CITY OF WEST LAKE HILLS, TEXAS
NOTICE OF CITY COUNCIL REGULAR MEETING
Wednesday, January 13, 2021 at 7:00 PM

Agenda Item: Land Use: 809 Canyon Creek: Discussion/consideration of several variance requests in order to rehabilitate/remodel an existing home that is non-conforming: 1) Reduction/encroachment of the interior side setback for new steps to the deck, rehabilitate an existing overhang, and rehabilitate the existing structure; 2) Encroachment into front setback to allow the rehabilitation of the existing structure and add new rain screen overhang over the front door; 3) Encroachment into side street setback for rehabilitation of the existing structure and addition of overhang; 4) Replacement of a failing retaining wall on the right side of the house encroaching in the setback and is taller than the maximum 18 inches height; 5) Cut/fill and construction of new retaining wall on left side of the house that encroaches the setbacks and is greater than 6ft in height; 6) Grading and drainage/cut to the left of the house in a setback; 7) Remove Tree # 182 - a 14 inch Chinese Tallow. (West Lake Hills Code Sections 22.03.275(3); 22.03.276; 22.03.170(g), 22.03.304(4), 22.03.281). Owner

809 CANYON CREEK
DRAINAGE ANALYSIS
DRAINAGE AREA MAP
SHEET 1

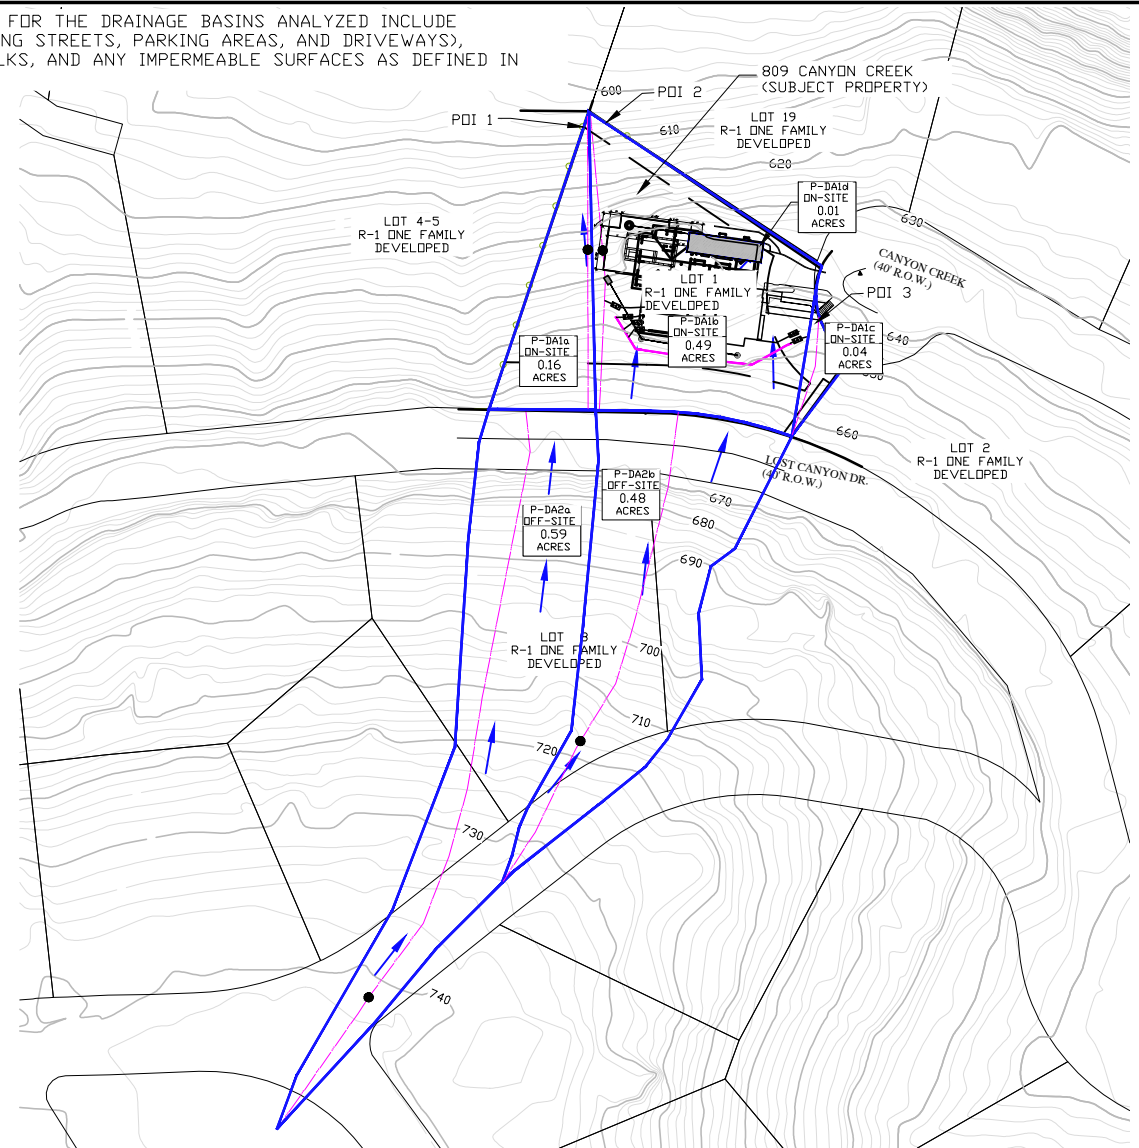
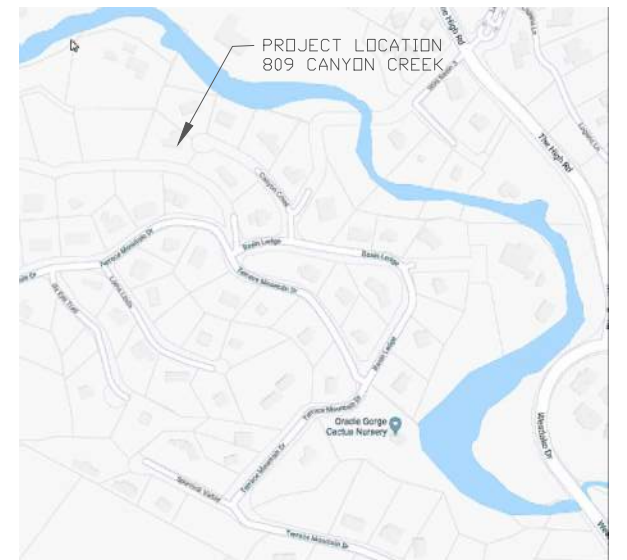
1. Please verify the area of the lot. The plat submitted shows the lot size as 0.64 acres and the plans show the lot size as 0.7 acres.

3-R1) Additional detail and calculations have been provided. Sheet 1 – Drainage map has been updated with three points of interest, 1. Cul-de-sac/RPW 2/ Side lot line, and 3. Back lot line. The calculations clearly show the proposed drainage patterns and demonstrate calculations and modeled results showing a decrease in peak flows along the property as required. Note that plans identify grading to maintain designated drainage boundaries and the proposed wall area will entirely drain to the POI2 and have plenty of distance to drain in a sheet flow manner at the property line, with NO increase in peak flows.

2-R1) The drainage map (SHEET 1) and table shown in calculation sheet (SHEET 3) have been updated and now match.

809 CANYON CREEK
DRAINAGE IMPROVEMENT PLAN
ON-SITE DRAINAGE PLAN
& SOIL EROSION CONTROL
SHEET 2

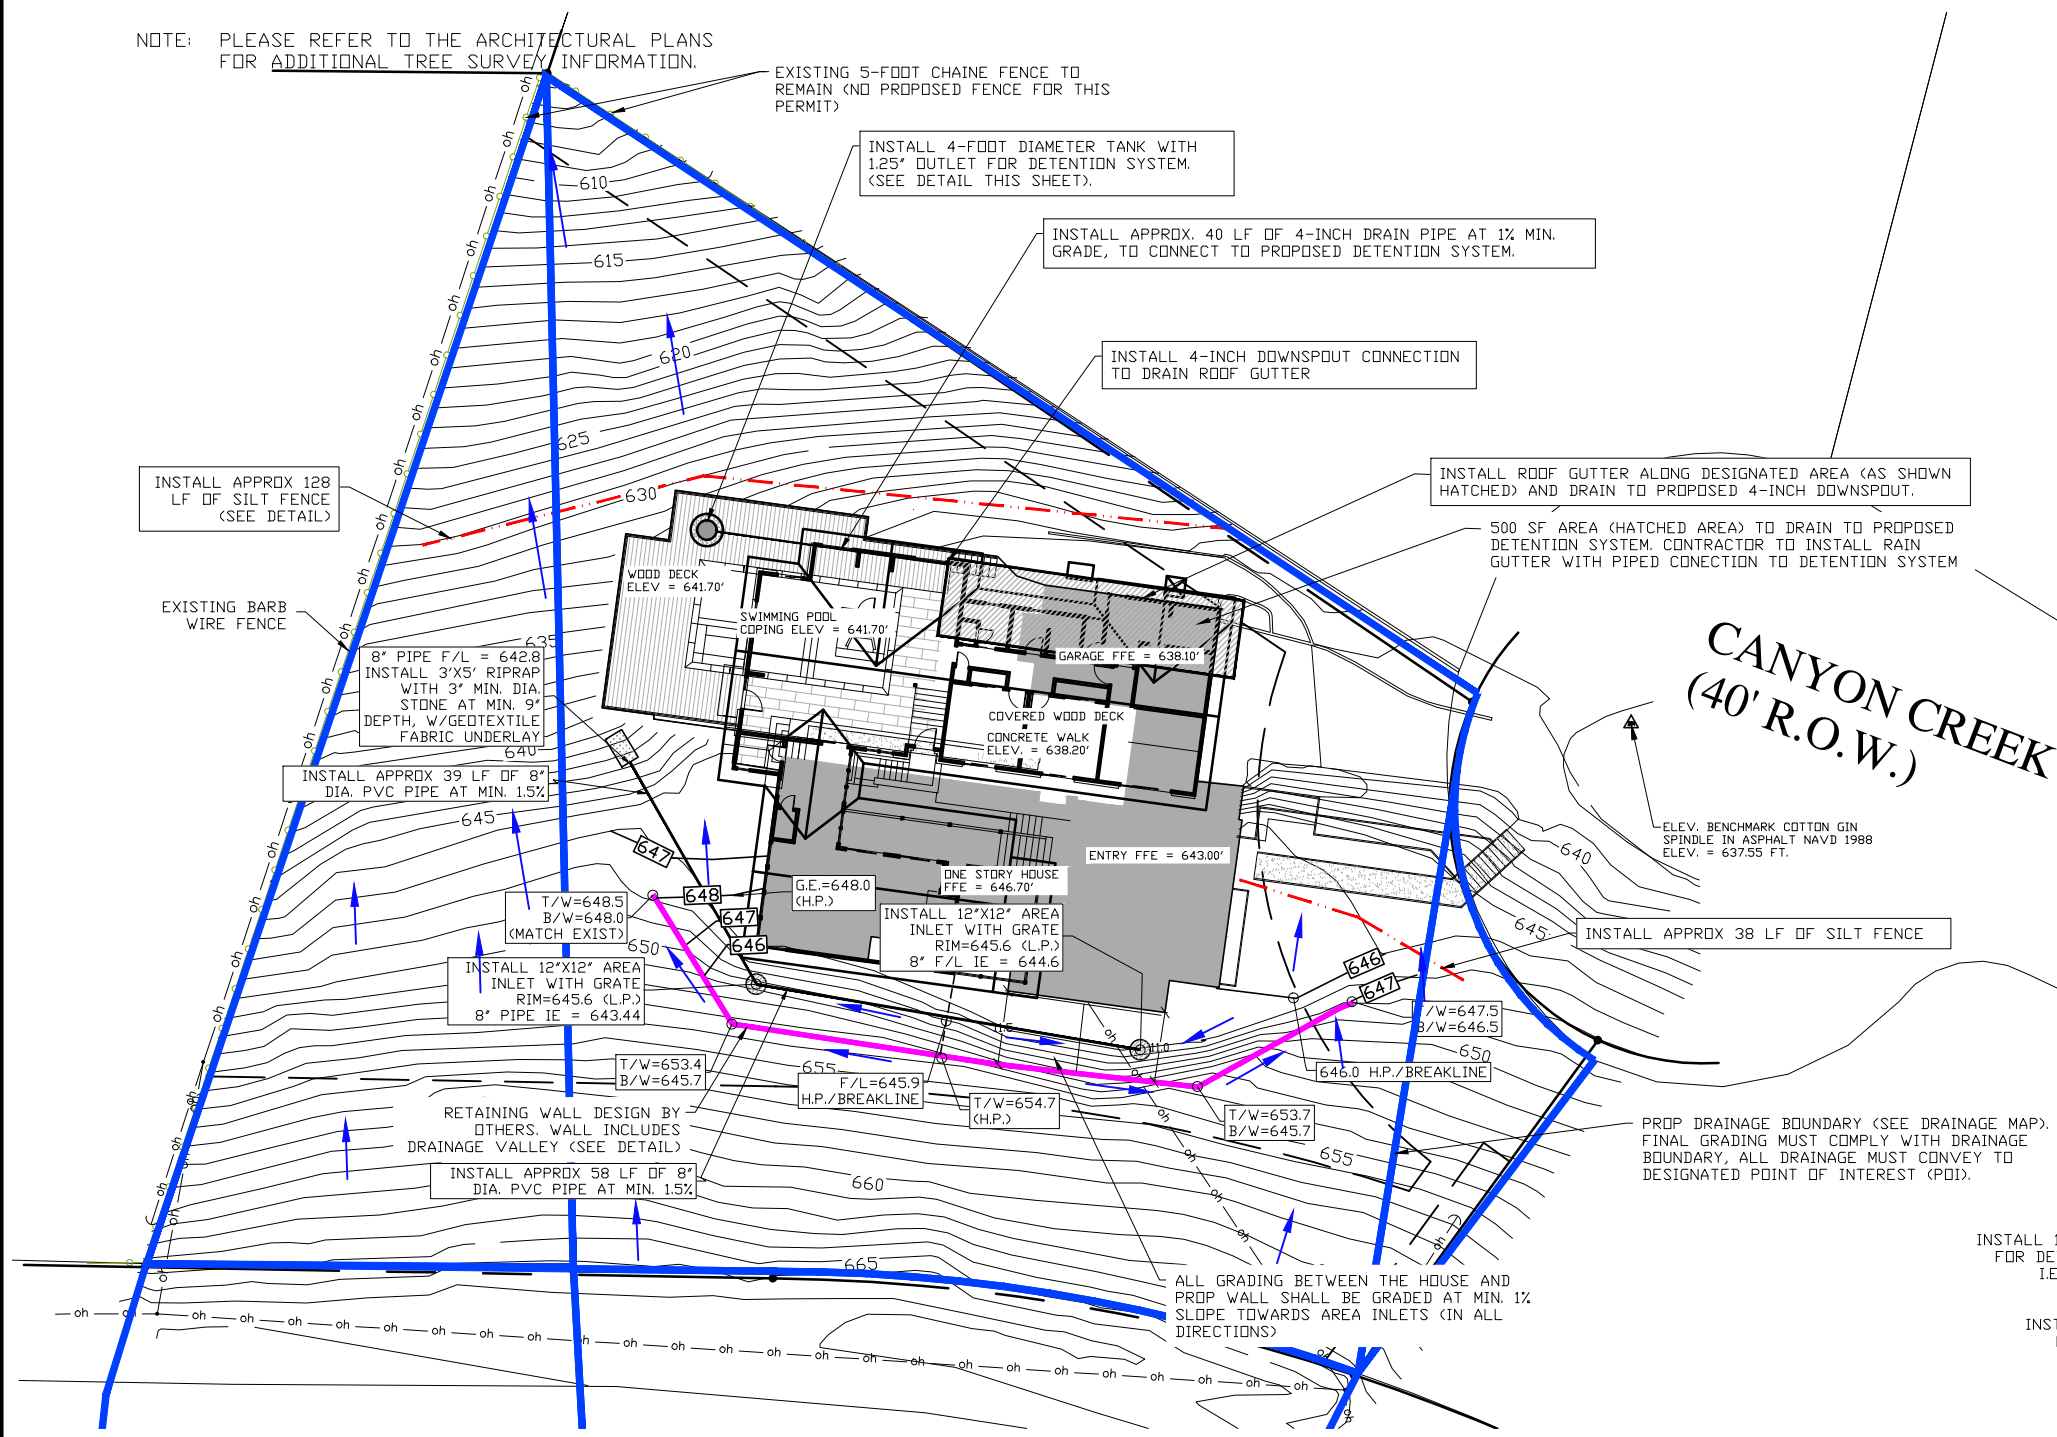
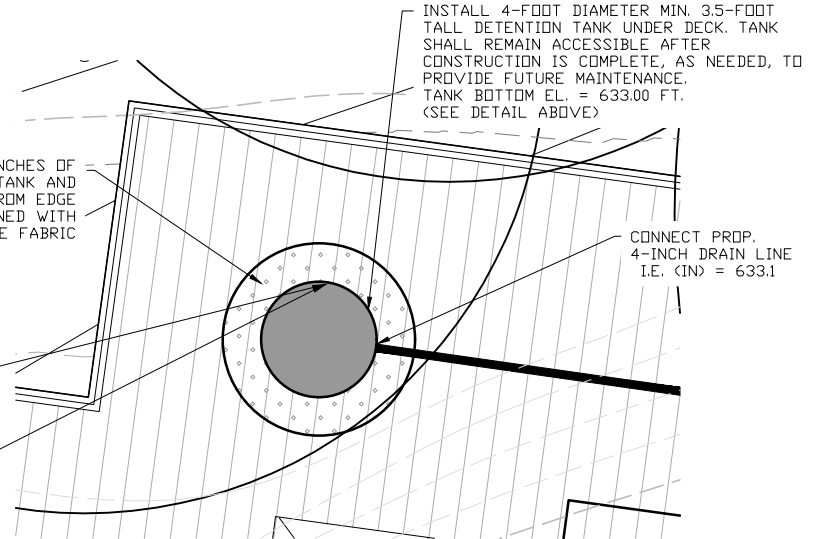
2. Provide the location of all existing and proposed fences including the type of fence.
2-R1) Existing fence demonstrated and labeled on Sheet 2, no proposed fence.
2-C1) Cleared.

3. Please provide spot elevations and finished floor elevations for the proposed structures, slabs, driveways, porches, patios, pools and outbuildings on all sides. Finished grades are required to be sloped to direct stormwater away from the structures.
3-R1) Sheet 2 provides spot elevations and grading plans.
3-C1) Cleared.

6. Rainwater harvesting is not an approved detention method for the City of West Lake Hills. Please provide proper stormwater mitigation.

7. Per the West Lake Hills Drainage and Erosion Control Design Manual Sec. 5.1(g), detention ponds shall be designed with an outlet structure to allow safe passage of the 100-year post-development design storm runoff. Provide calculations for the outlet structure and emergency spillway showing compliance.

7-C1) **Please provide calculations for the appropriate sizing of the overflow spillway.**

7-C2) **Please revise detention system detail on sheet 2. Only the callouts are shown. Please provide calculations or HEC-HMS output for emergency overflow spillway.**

8. Provide the 100-year WSEL for the pond and indicate the freeboard. Freeboard of at least 1.0 foot within the pond must be provided per West Lake Hills Drainage and Erosion Control Design Manual Sec. 5.1(p).

6-R1) *Note that the proposed conditions do not exceed 20% IC and rainwater harvesting is not proposed for this permit. The collection system is intended for detention purposes only. Adjustments have been made to Sheet 2 for clarity.*

7-R1) *See Sheet 2 for proposed detention pond plan. Note that a 4-foot diameter tank is identified for detention purposes and will not be used for water quality or any other purpose other than providing detention needed to comply with WLH drainage requirements. Calculations are provided on sheet 3.*

7-R2) *Spillway has been added to detention system. HEC-HMS was used to analyze/size pond, outlet, and emergency overflow spillway.*

7-R3) *Sheet 2 has been updated for cross-sectional detail. Calculation for the pond along with elevations demonstrated for each storm event, are shown on Sheet 3.*

8-R1) *Calculations and details are provided on Sheet 3 and include the required 1 foot freeboard. Sheet 2 provides a cross sectional detail of the detention pond with the 100 year WSEL freeboard demonstrated.*

809 CANYON CREEK
DRAINAGE IMPROVEMENT PLAN
CALCULATIONS & DETAILS
SHEET 3

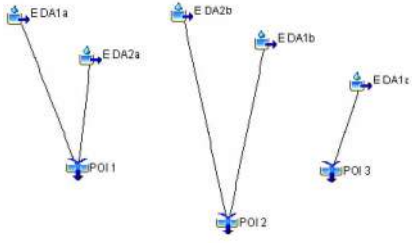
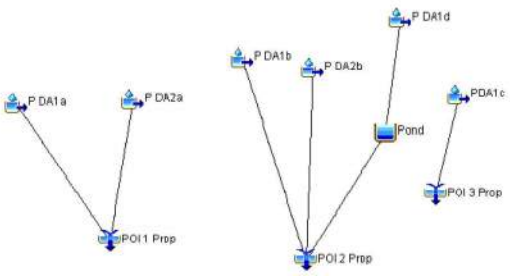
5. Verify the sheet flow calculations as it appears the manning's "n" coefficients for DA E1 and DA P1 are inconsistent with the West Lake Hills Drainage and Erosion Control Design Manual Table 3-5.

5-C1) **Please verify manning coefficient used for the offsite drainage areas. The coefficient 0.24 is used which corresponds to dense grass, however the first 100 feet of flow appear to be on a roadway.**

9. Per the West Lake Hills Drainage and Erosion Control Design Manual Sec. 5.3, provide the stage, storage, and discharge summary table for the 2-year, 10-year, 25-year, and 100-year storm events.

5-R1) *Manning's Coefficients are shown on Sheet 3 and comply with WLH D&EC Design Manual.*

5-R2) *Calculations are updated, see Sheet 3.*

9-R1) *The required table is provided on Sheet 3.*

809 CANYON CREEK
DRAINAGE ANALYSIS
DRAINAGE PLAN
SHEET 4

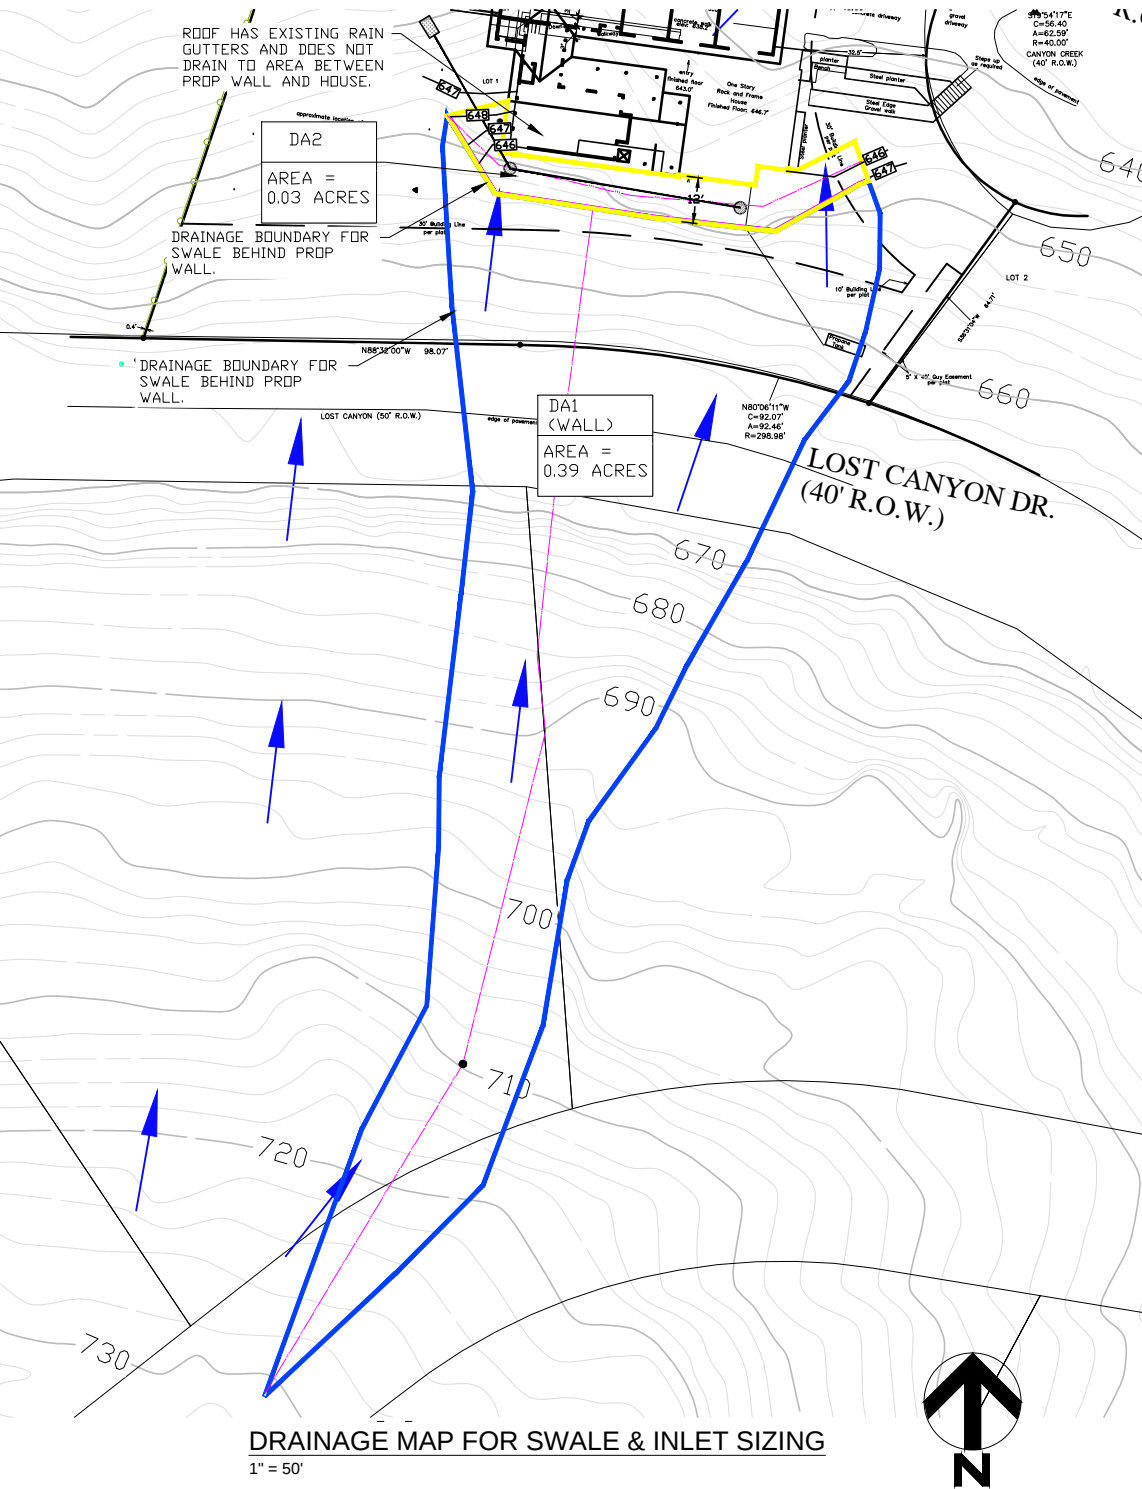
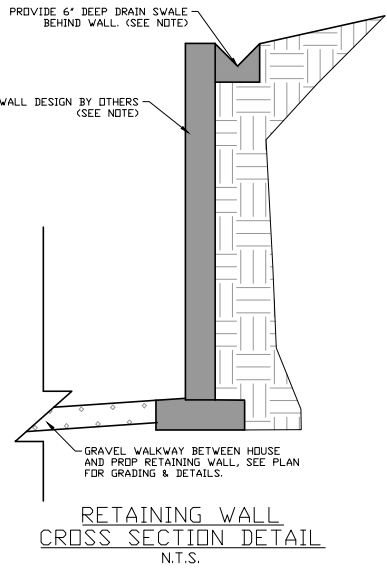
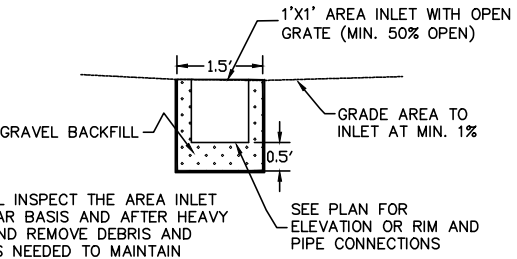
1. Finished grades are required to be sloped to direct stormwater away from the structures. Finished floor elevations of structures adjacent to stormwater conveyance must have floor slab elevation or bottom of floor joists at or above the 100-year water surface elevation. Please provide calculations demonstrating compliance with the swale between the wall and the house.

2. Please verify the lag time calculations for the onsite drainage is correct if the minimum time of concentration used is 10 minutes.

2. The plans and drainage report indicate there is a swale upstream of the wall and indicate there is a detail. No detail is shown in the plans.

1-R2) *The swale has been removed and area inlets are proposed to drain area between the house and proposed wall. The drainage system capacity surpasses the 100 year max peak flow and all calculation are provided on Sheet 4.*

2-R1) *Lag time have been revised as directed and updated values are used with the HEC-HMS analysis. See Sheet 4 for updated tables, calculations, and HMS results.*

2-R1) The detail for the retaining wall has been added to Sheet 4.
